82546EB Gigabit Ethernet Controller Specification Update

September 26, 2006

The *82546EB* Gigabit Ethernet Controller may contain design defects or errors known as errata that may cause the product to deviate from published specifications. Current characterized errata are documented in this Specification Update.

8. 1.5V Regulator Control Circuit Start Up

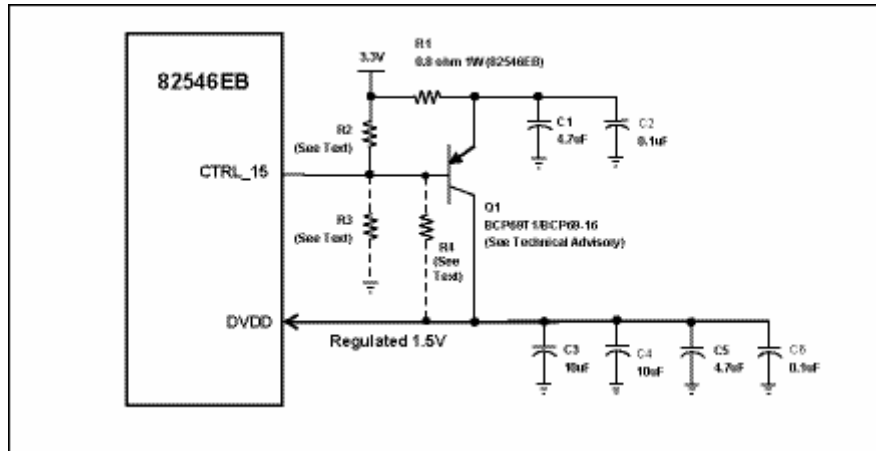
- Problem:** The 82546EB products contain on-chip LDO voltage regulation controllers for both 1.5V and 2.5V. The 1.5V regulator control output, CTRL_15, sometimes powers up in a high impedance state due to a digital portion of the feedback-control circuit which requires 1.5V to be present to operate correctly. The rate of occurrence of this problem may appear to vary from device to device or with different PNP transistors.

- Workaround:** The regulator control output is Ball A18 on the 82546EB controller. Intel's original reference designs showed two external resistors, R1 and R2, in this circuit (refer to the following figure)

- The workaround is to completely remove R2 (also shown in the reference schematics as R6 @ 5.1K Ω) and place another resistor, R4, (also shown in the reference schematics as R7 @ 30.1K Ω 1%) to connect between the base of the PNP transistor and the 1.5V VDD output. Existing designs may alternatively use resistor R3 (not shown in the reference schematics) to connect between the CTRL_15 output and ground (refer to the following figure).

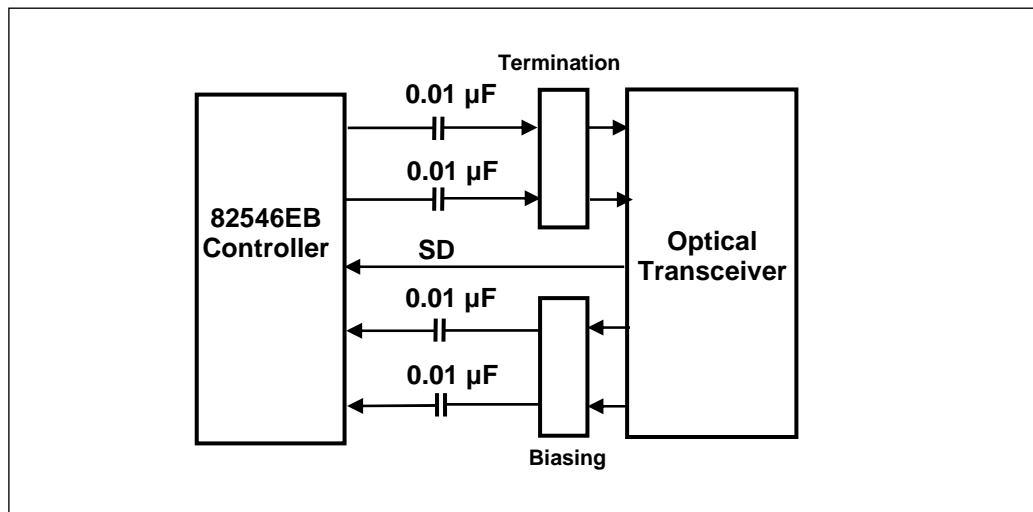
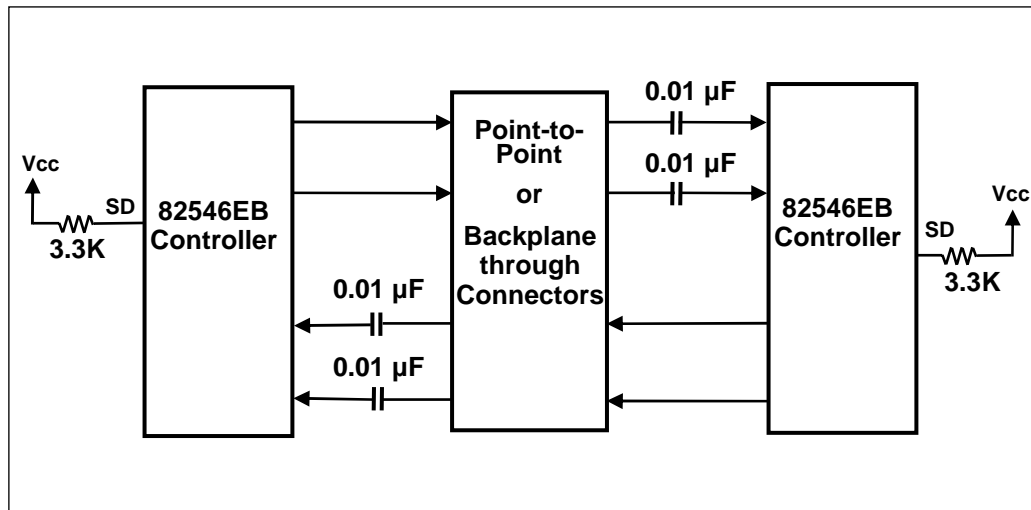
Problem: Intel added new SERDES functions to the 82546EB. SERDES stands for Serializer-Deserializer and is a circuit that converts Ethernet packet data from a parallel TBI format to a 1.25 GHz bidirectional serial stream. For 1000BASE-SX or 1000BASE-LX fiber applications, SERDES integration typically saves the designer the expense and board space of a 64-lead external device. The 82546EB Controller contains two integrated SERDES units and the 82545EM Controller contains one SERDES. A '10' needs to be written in ICW3 bits 1 and 0, respectively, in order to enable this feature.

82546EB fiber-based applications will use the SERDES interface to drive a 1000BASE-SX or 1000BASE-LX optical transceiver as illustrated in the following figure. The 82546EB controller is internally terminated, so no external termination is required.

Alternatively, the 82546EB controller may be used in short haul gigabit backplane data applications without transceivers and optical fibers. No special termination is required because the 82546EB device is internally terminated. The figure below illustrates a gigabit backplane or point-to-point circuit based on the 82546EB device:

The datasheet for the 82546EB Controller will change to define pins as follows:

How to Reduce the Case to Ambient Thermal Resistance, θ_{CA} , for LOM Designs

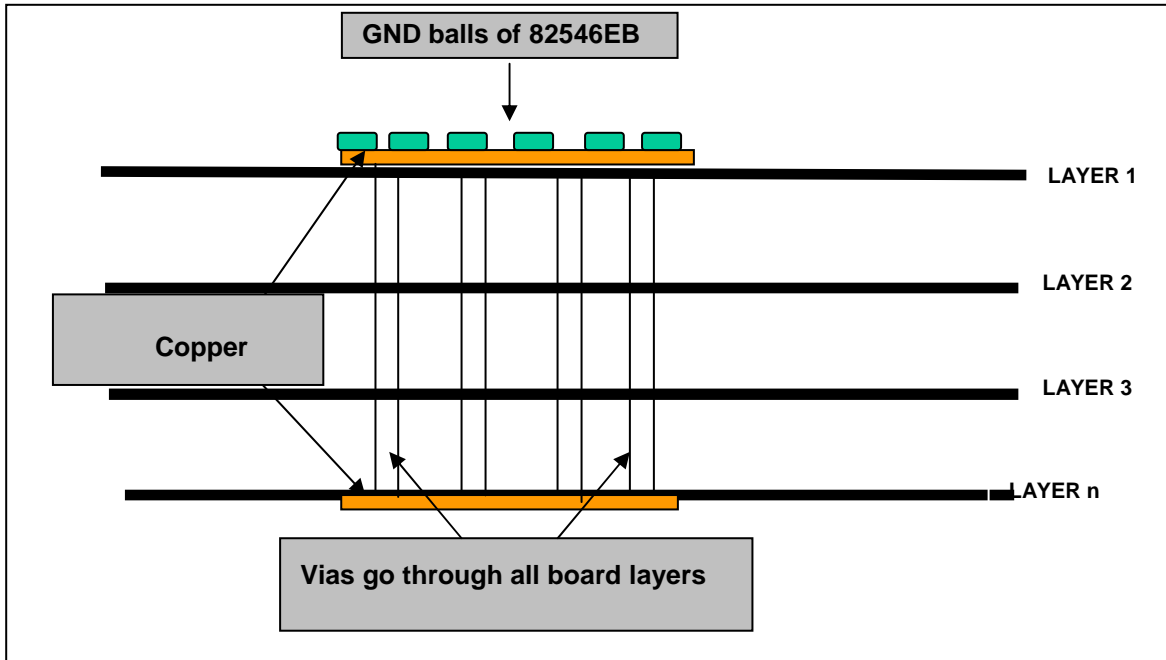
One element that designers can influence in their designs is the thermal resistance θ_{CA} . If increased airflow is not an option, the thermal resistance can be reduced by adding a heat sink to your 82546EB Controller PCB design. The manufacturers of add-on heat sinks should provide detailed literature and technical reports on improvements in θ_{CA} with their products.

An alternative is build a heat sink into the printed circuit board. This is can be accomplished by adding copper to the board and drilling numerous thermal vias for heat dissipation under the BGA package.
